SUBMITTAL TRANSMITTAL

Submittal No: 05500-009.A

PROJECT: **Harold Thompson Regional WRF**
Birdsall Rd.
Fountain, CO 80817
Job No. 2908

SUBJECT: Re-submittal for the Aeration Basin/Digester Stairs

Project	HAROLD D. THOMPSON REGIONAL RECLAMATION FACILITY	Date	1/23/2012
Area	LOWER FOUNTAIN METROPOLITAN SEWEGE DISPOSAL DISTRICT	Drwn By	DWN
Detail	DETAILS --- STAIRS PER 1/AB-8	Rev:	2
Ref Dwg	NOTED	Date:	3/21/2012
Scale	NONE	Sheet	S-12

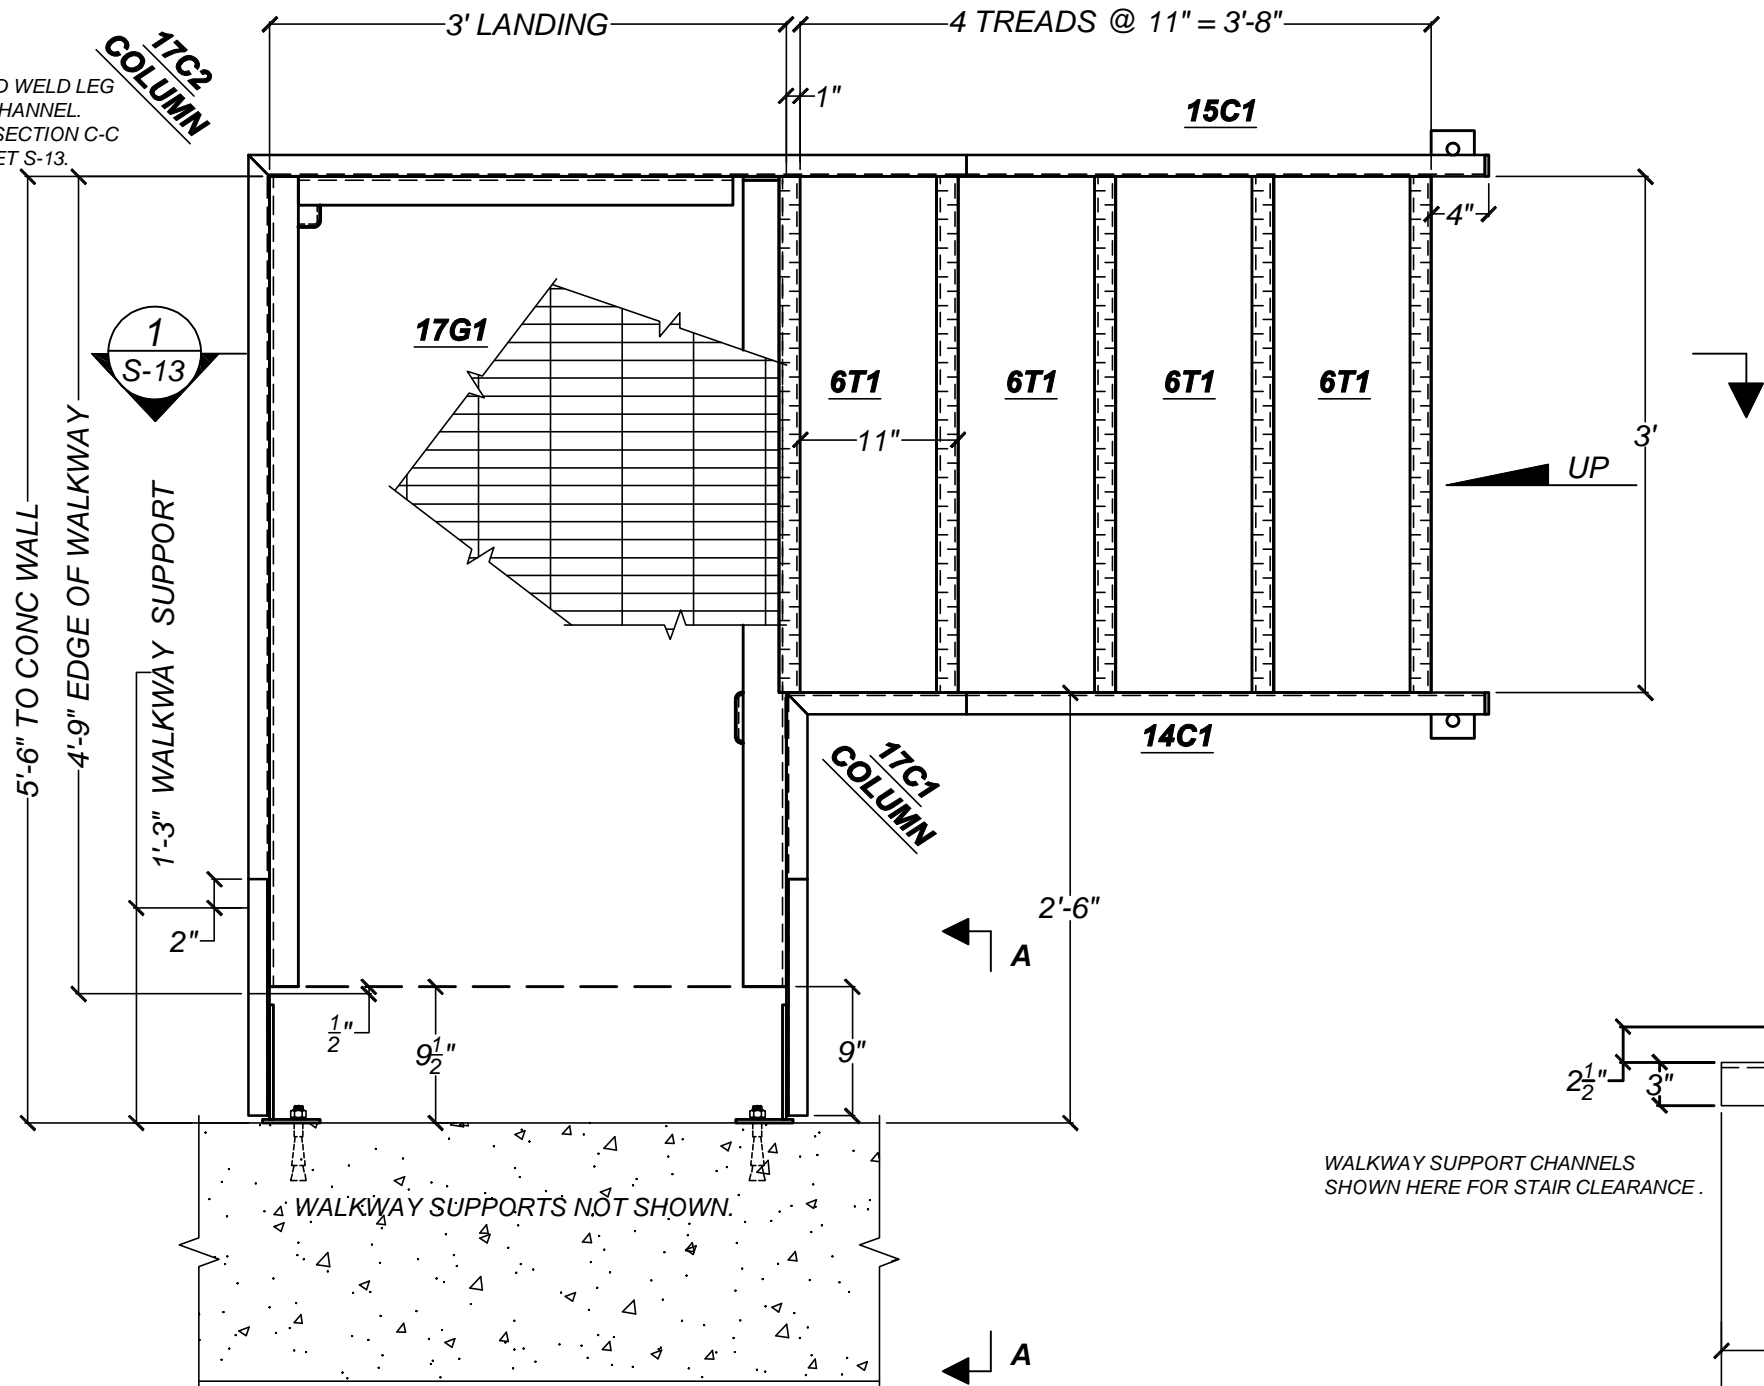
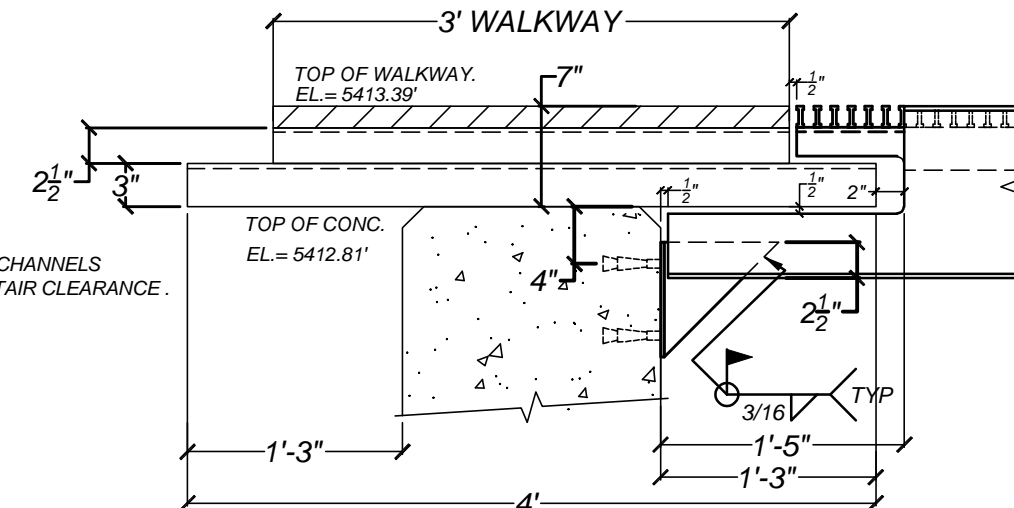
7. Sheet S-11: **No Exception Taken** No change.
8. Sheet S-12: **Revise and Resubmit** Changed per this document & added note.
- a. The plan view of the stair indicates 1½-inch aluminum I-bar non-slip treads will be utilized. All stair treads must be serrated aluminum tread. This also applies to the elevation section view.

GALVANIZED STRINGERS & LANDING.
1-1/2" ALUMINUM SERRATED or ~~STRIATED I-BAR~~
TREADS.
1/AB-8 STAIR. AERATION BASIN STAIR AT THE
SOUTH/WEST CORNER.

Project	HAROLD D. THOMPSON REGIONAL RECLAMATION FACILITY	Date	1/23/2012
Area	LOWER FOUNTAIN METROPOLITAN SEWEGE DISPOSAL DISTRICT	Drwn By	DWN
Detail	DETAILS --- STAIRS PER 1/AB-8	Rev:	2
Ref Dwg	NOTED	Date:	3/21/2012
Scale	NONE	Sheet	S-17

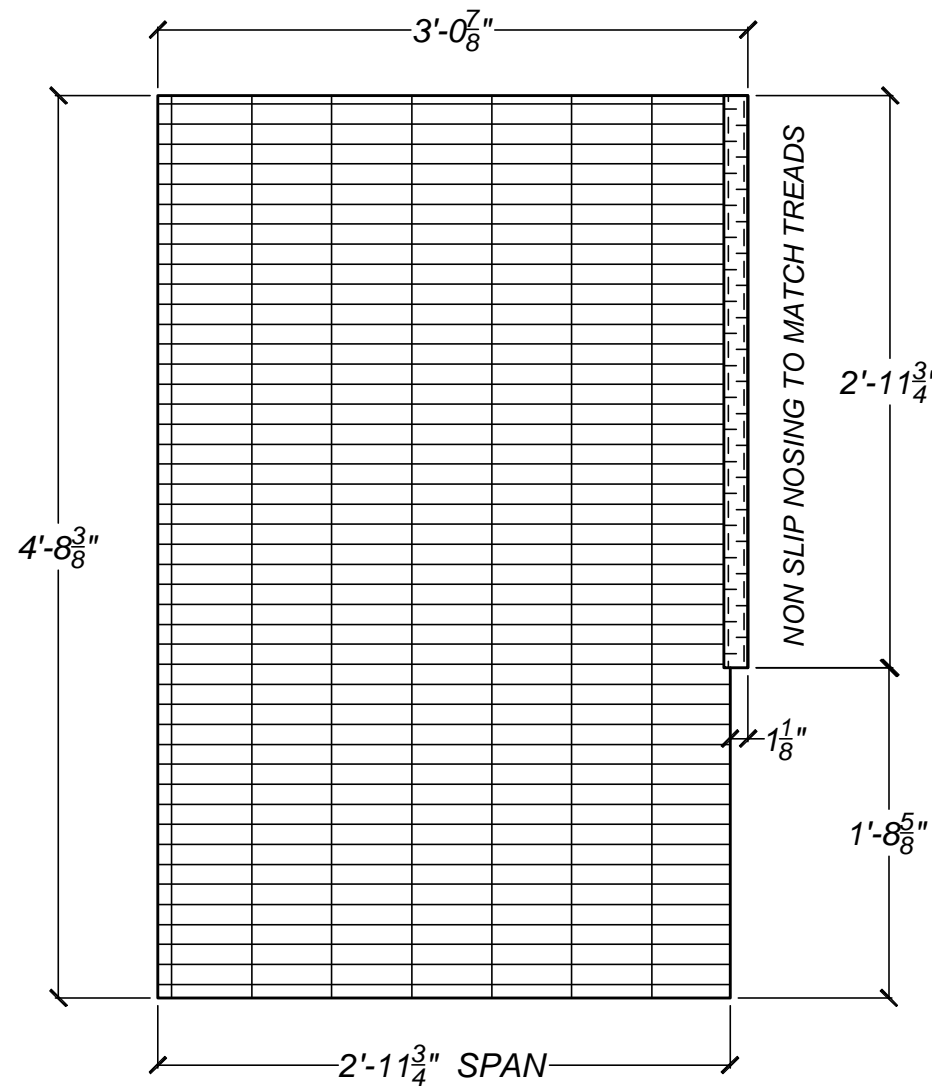
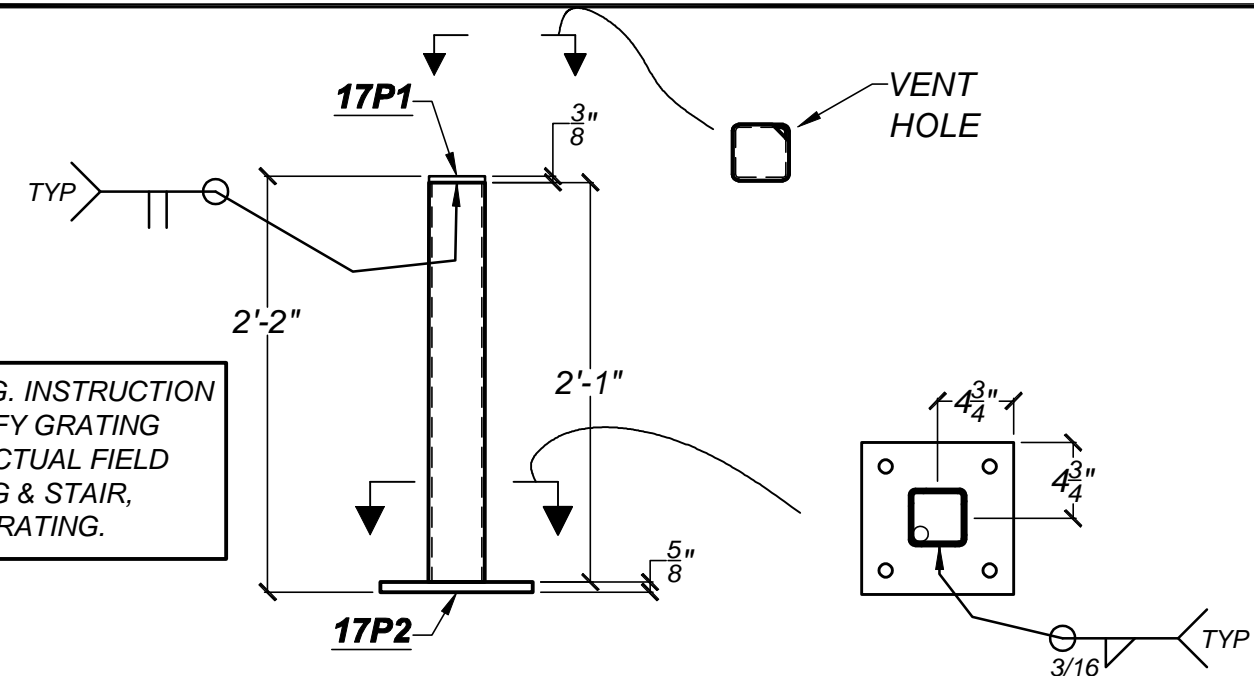
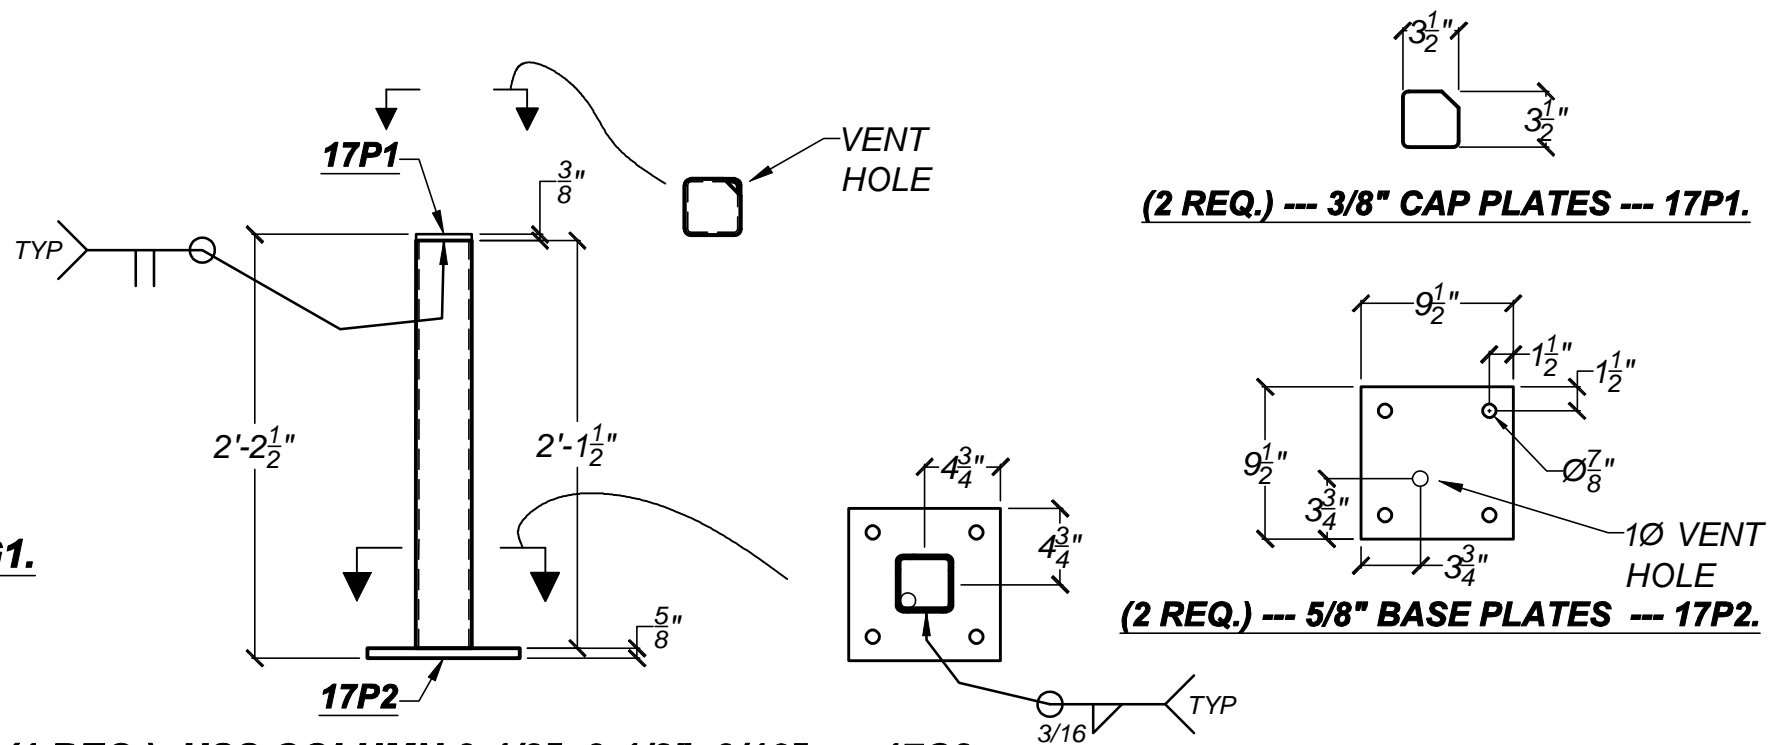
13. Sheet S-17: **No Exception Taken** Changed per this document & added note.
 - a. Per the shop note provided on the drawing, the 1½-inch aluminum I-bar grating with non-slip surface should be fabricated to fit actual field conditions once the grating frame has been constructed.

SHOP & FIELD NOTE: ENG. INSTRUCTION FIELD WILL NEED TO VERIFY GRATING DIMENSIONS TO MATCH ACTUAL FIELD INSTALLATION OF LANDING & STAIR, PRIOR TO FABRICATING GRATING.

Project	HAROLD D. THOMPSON REGIONAL RECLAMATION FACILITY	Date	1/23/2012
Area	LOWER FOUNTAIN METROPOLITAN SEWEGE DISPOSAL DISTRICT	Drwn By	DWN
Detail	DETAILS --- STAIRS PER 2/AB-8	Rev: 2	Date: 3/21/2012
Ref Dwg	NOTED	Scale	NONE
Sheet	S-18

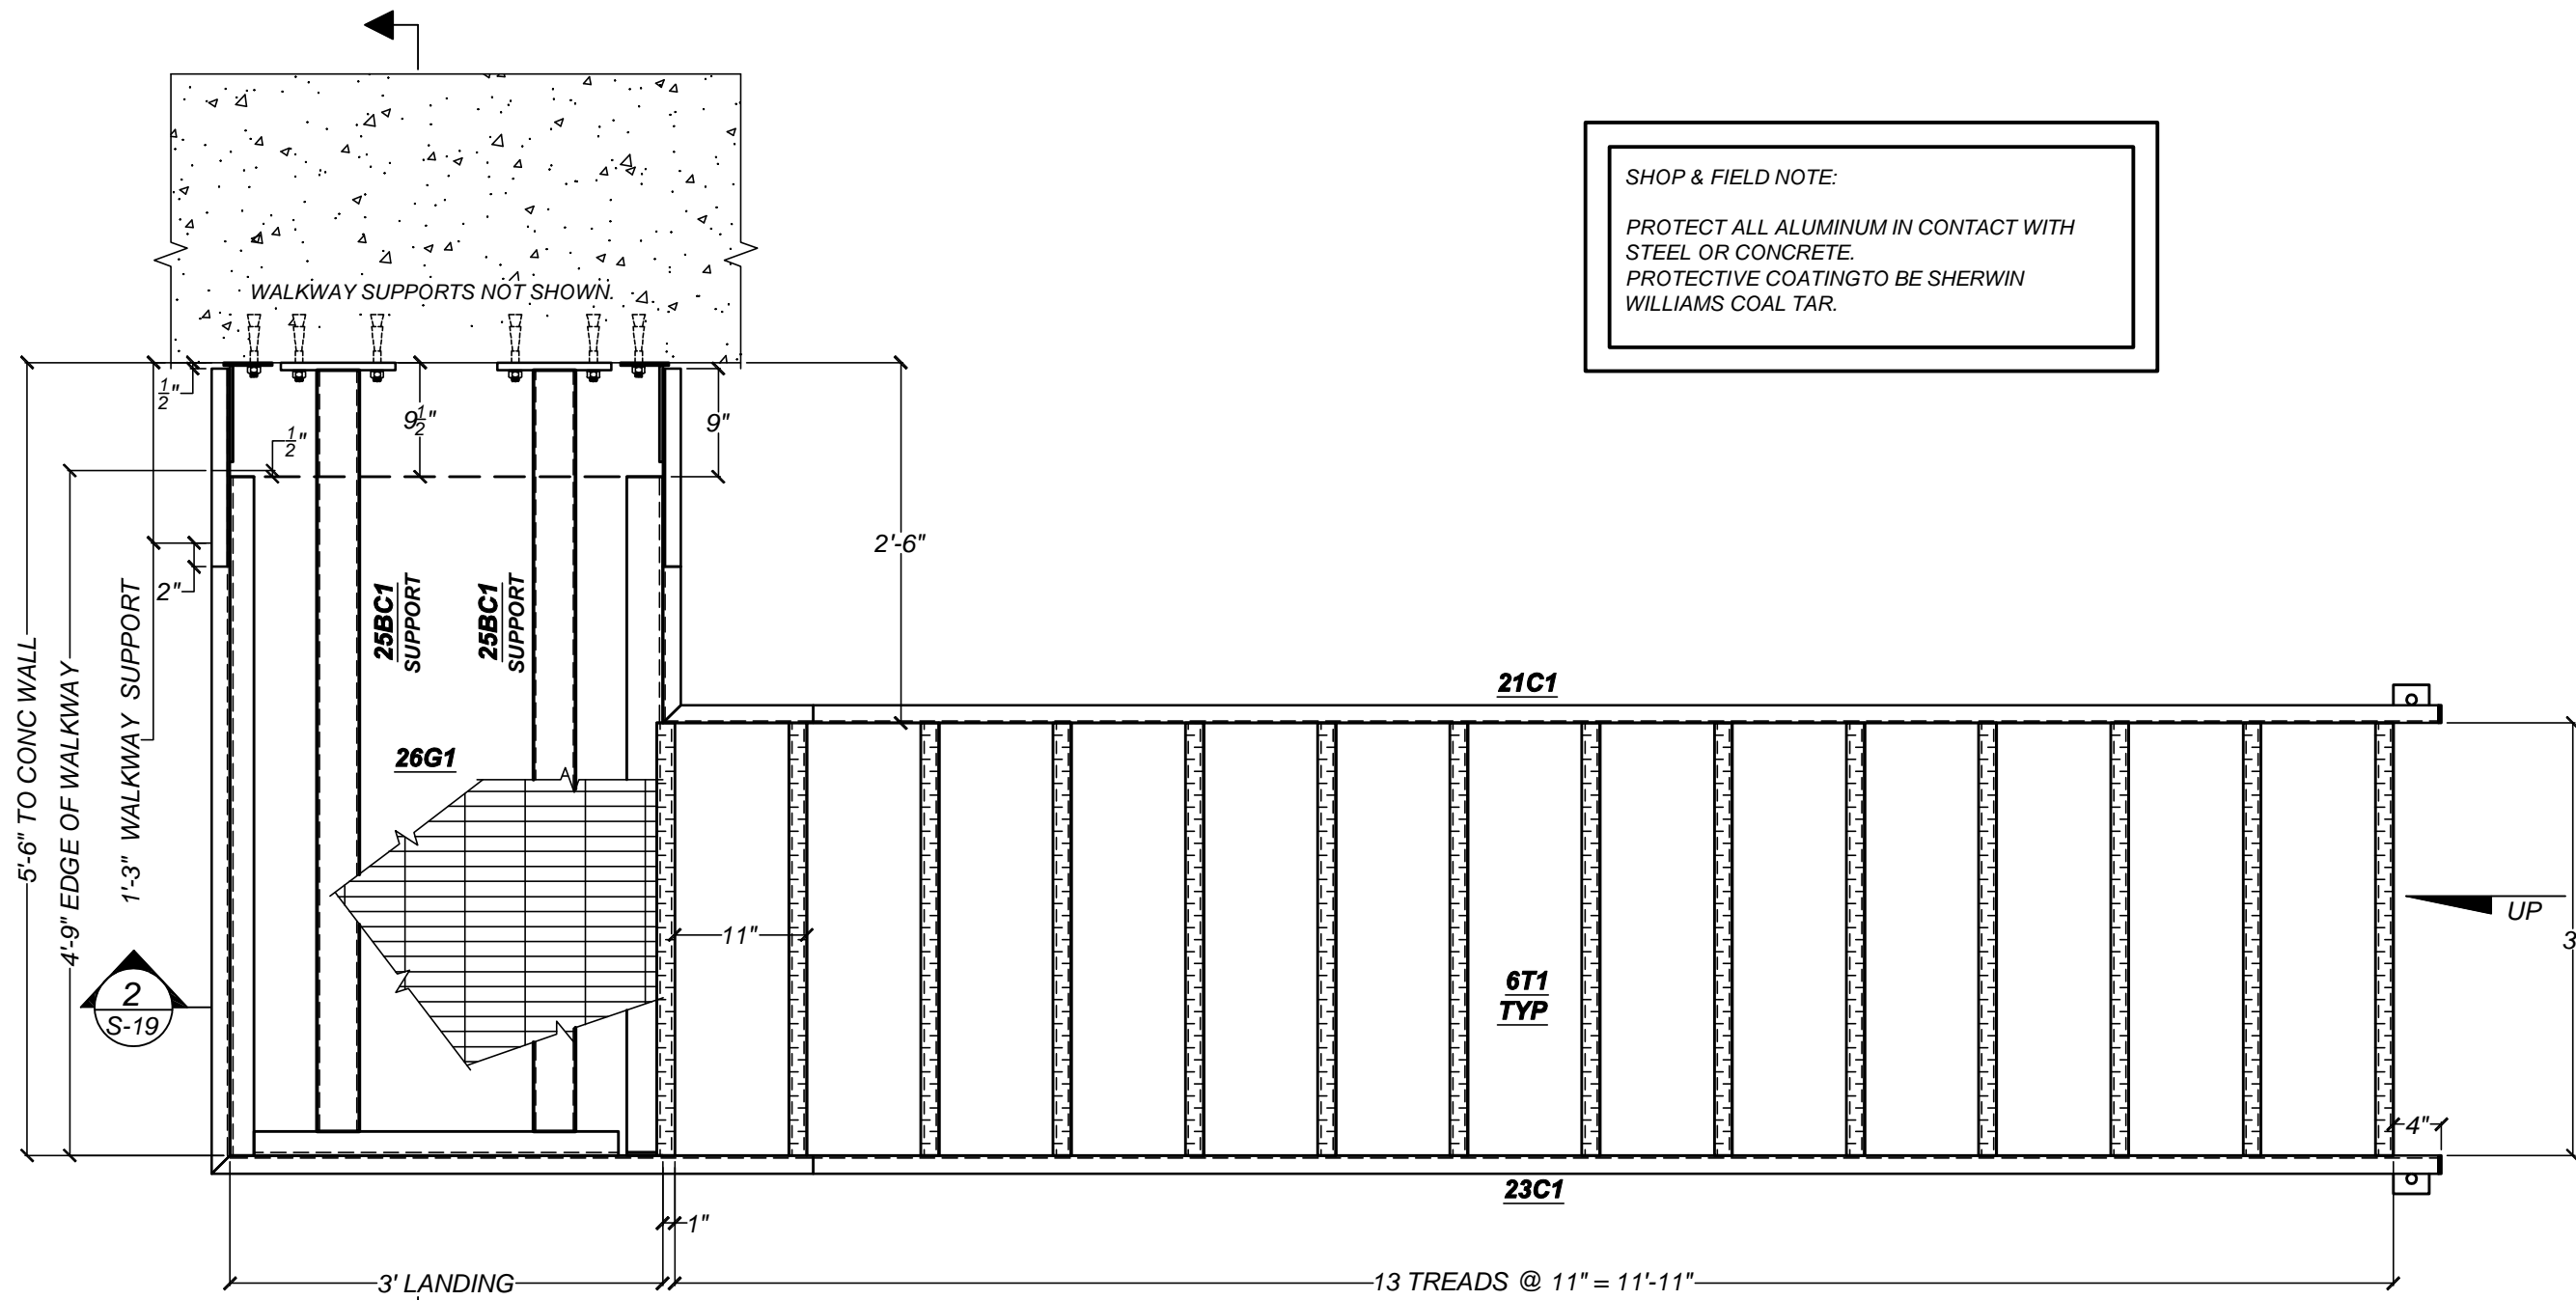
14. Sheet S-18: **Revise and Resubmit** Changed per this document & added note.
 - a. The plan view of the stair indicates 1½-inch aluminum I-bar non-slip treads will be utilized. All stair treads must be serrated aluminum tread. This also applies to the elevation section view.

GALVANIZED STRINGERS & LANDING.
 1-1/2" ALUMINUM SERRATED or ~~STRIATED~~ **BAR**
 TREADS.
 2/AB-8 STAIR. AEROBIC DIGESTER NO 3 STAIR AT
 THE SOUTH/EAST CORNER.
